Dave Morey
Vice President
Farley Project

Joseph M. Farley Nuclear Plant
Reactor Vessel Support Concrete Temperature
Reply to NCV 50-348, 364/00-01-01, Failure to Identify an USQ

Attachment 1
Response to
NCV 50-348, 364/00-01-01, Failure to Identify an USQ

FOOTPRINT OF REACTOR VESSEL
SUPPORT (TYPICAL 6 LOCATIONS)
LOADED AREA

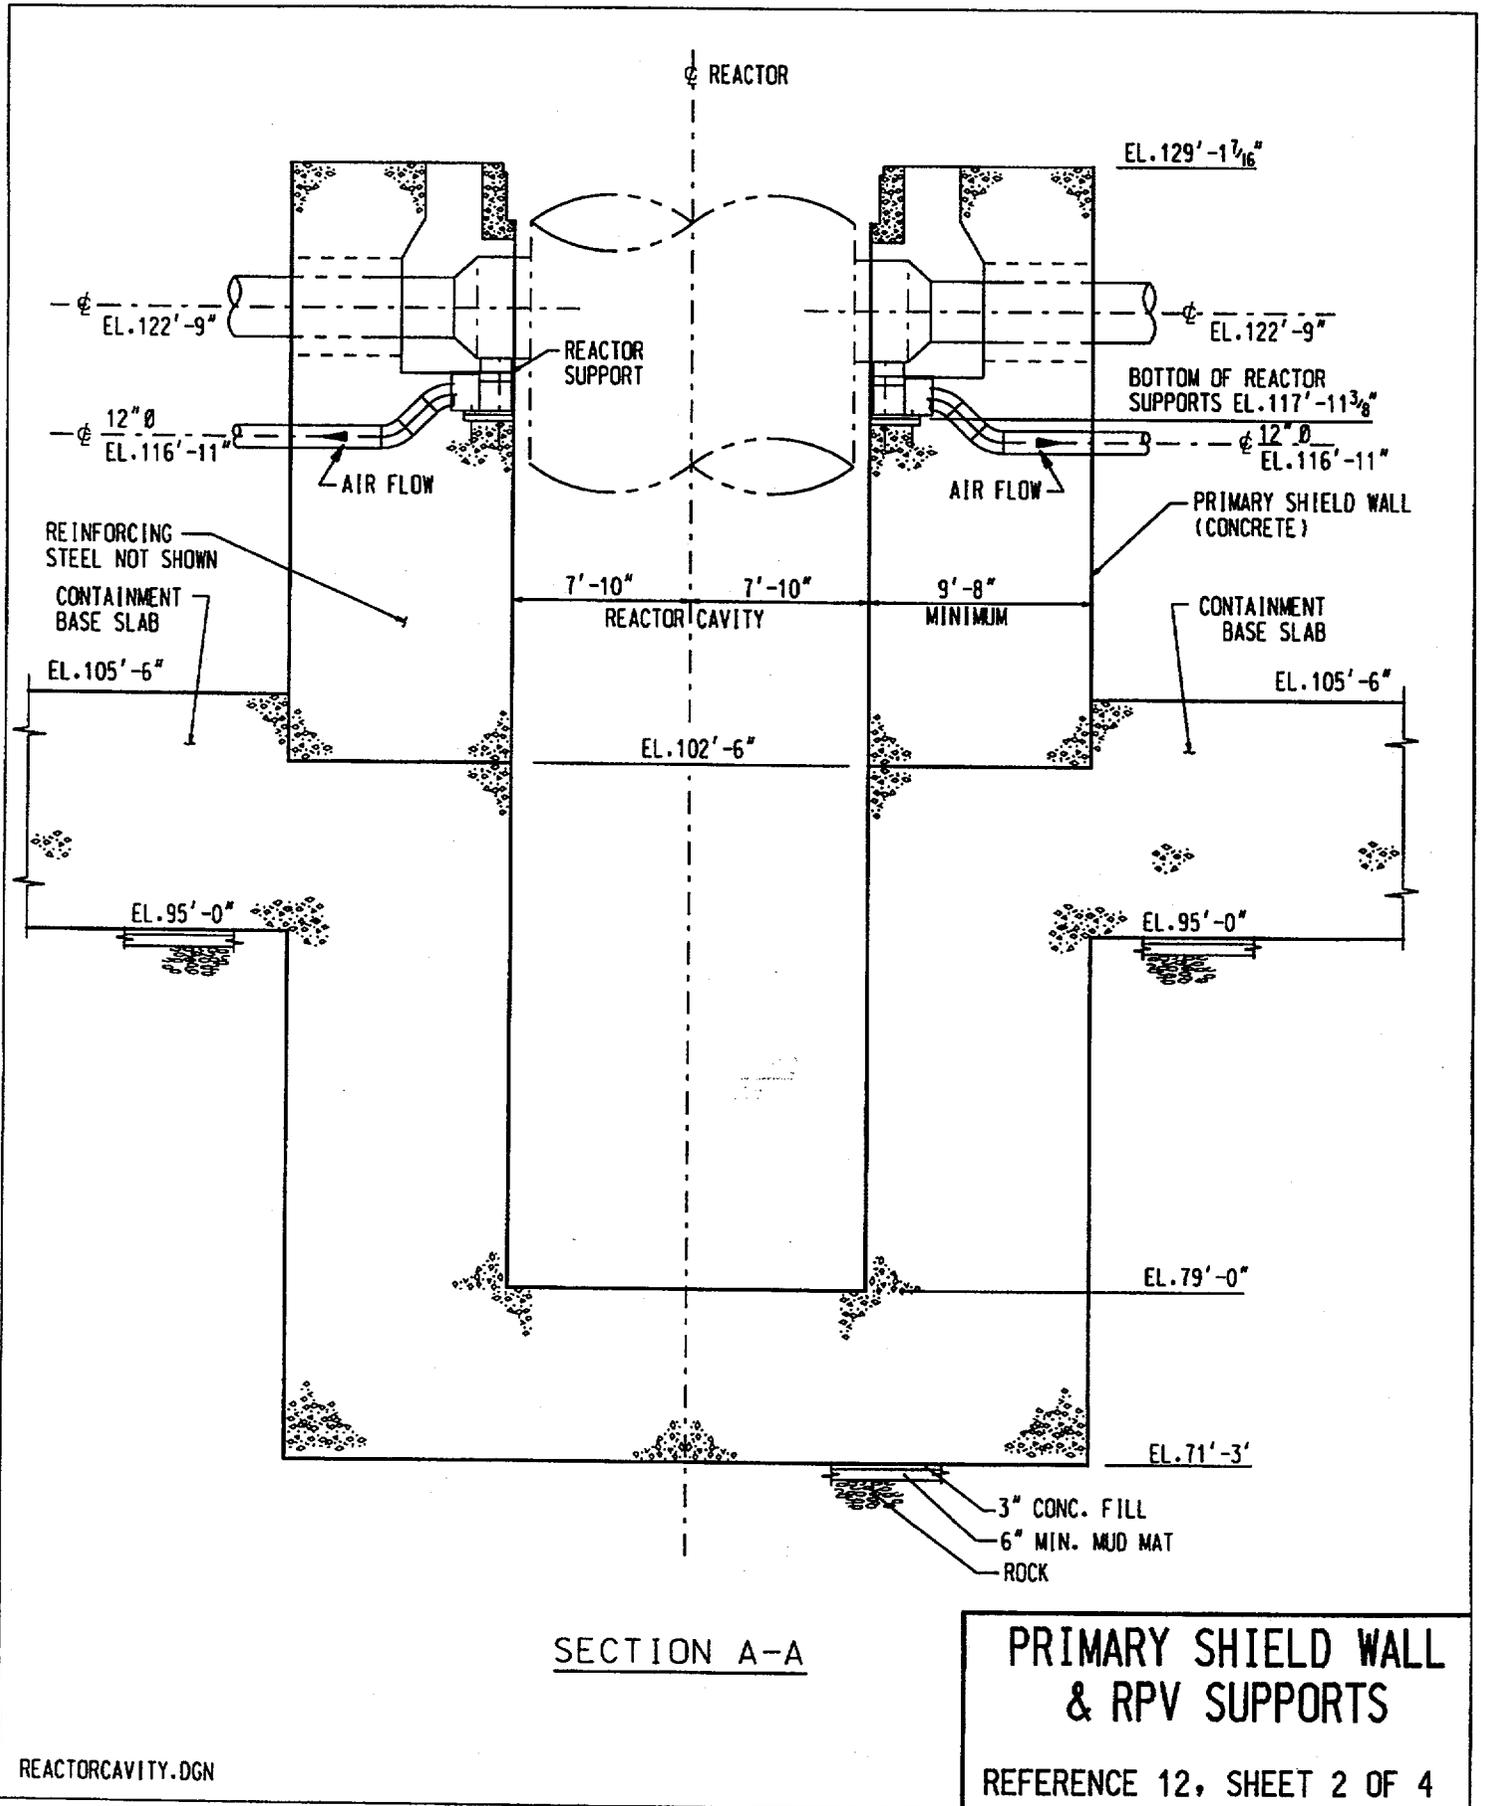
The total area of the contact surface of the base of the six supports is less than ten percent of the gross cross-sectional area of the primary shield wall. The calculated temperatures based on air flow distributions at the support/concrete interface for two of the six supports are below 150°F, approximately 165°F at two other supports, and approximately 190°F at the remaining two supports. The temperature in excess of 150°F is limited to four support locations and does not apply across the whole primary shield wall on which the reactor is supported, and is, therefore, a localized effect.

SECTION B-B

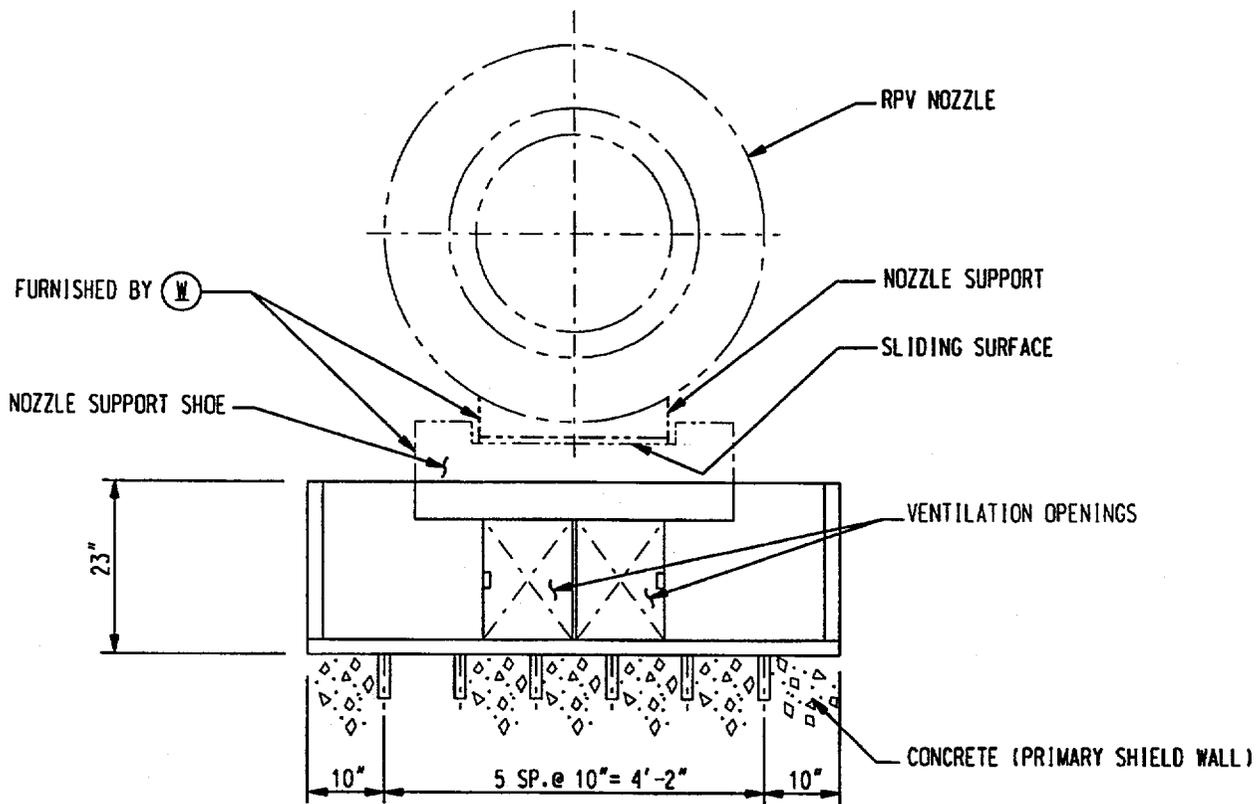
Based upon a very conservative thermal analysis model of the reactor pressure vessel support, which was constructed by Westinghouse, the maximum computed temperature at the interface of the bottom face of the support and the concrete support surface, was determined to be 190°F near the center of the support (Point A, Reference 12) further localizing the peak temperature. The temperature gradient is shown to decrease outwardly from the support center to the extreme edges of the length of the plate (Point B, Reference 12). The analysis assumes no heat transfer into the concrete, but utilizes the bottom of the plate as a boundary condition. Further, the support is welded to the liner plate of the reactor cavity, which would further transfer heat flow into the concrete thus potentially reducing the peak local calculated concrete temperature. Other conservative attributes consist of the actual strength attained in the concrete mass, based on test specimens taken at the time of concrete placement and additional strength gain between the time the concrete was placed and until actual heat up of the nuclear steam supply system (NSSS) occurred.

APPROXIMATE FLOW PER SUPPORT BASED ON ORIGINAL STARTUP TESTS		
SUPPORT NO.	FLOW (CFM)	PEAK CALCULATED TEMPERATURE °F
1	≈ 2150	≈ 183
2	≈ 2600	≈ 165
3	≈ 4700	≈ 120
4	≈ 3250	≈ 140
5	≈ 2700	≈ 160
6	≈ 2000	≈ 190
